Product Change Notification / LIAL-24K0XB344

CCB 4477 Final Notice Implement additional cover tape, carrier tape and plastic reel material supplier for selected Micrel products available in 3L, 5L, 6L and 8L SOT23, 5L and 6L TSOP and 8L SOIC packages at STAR assembly site.

**CCB 4477: Implement additional cover tape, carrier tape and plastic reel material supplier for selected Micrel products available in 3L, 5L, 6L and 8L SOT23, 5L and 6L TSOP and 8L SOIC packages at STAR assembly site.
PCN#: LIAL-24K0XB344**

Plastic Reel 7 inch for SOT23-3/5/6/8L , TSOT-5L/6L

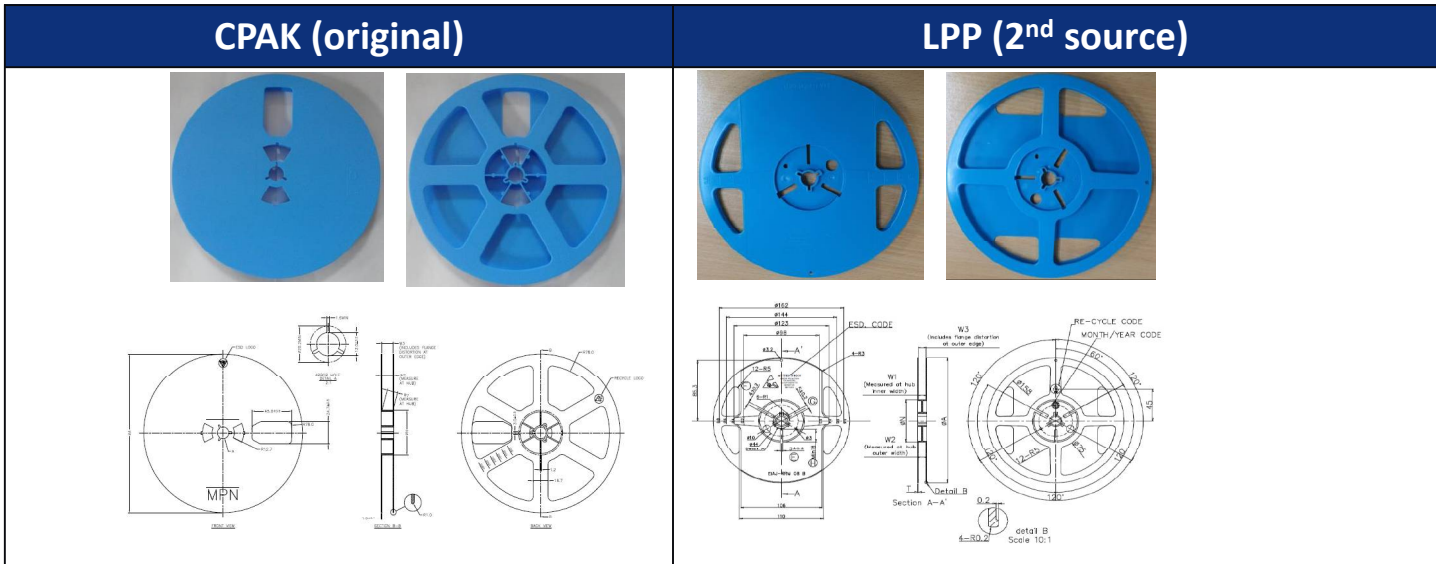
Supplier	Carrier Tape Width (W1)	Diameter (ΦA)	Hub (ΦN)	Color
CPAK	8.4 +1.5/-0 mm	180 mm max	50mm min	Blue shade
LPP	8.4 +1.5/-0 mm	172 ± 2.0 mm	60.5 ± 0.50mm	Blue shade

CPAK (original)

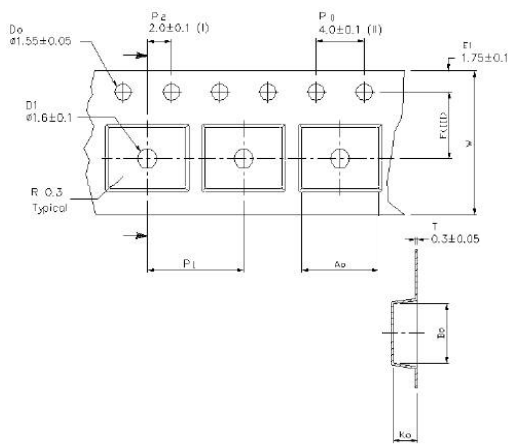
Carrier Tape Supplier	Supplier Mfg. part no.	Width (mm)	Pitch (mm)	A0 (mm)	B0 (mm)	K0 (mm)	Thickness (mm)
CPAK	CPD-092A	12.00 ±0.100	8.00 ±0.100	6.40 ±0.10	5.20 ±0.10	2.10 ±0.10	0.30 ±0.05
3M	TWO13611-4	12.00 +0.30/-0.10	8.00 ±0.100	6.40 ±0.10	5.20 ±0.10	2.10 ±0.10	0.30 ±0.02
U-PAK	UPKSOIC08A-SMS	12.00 ±0.100	8.00 ±0.100	6.40 ±0.10	5.20 ±0.10	2.10 ±0.10	0.30 ±0.05
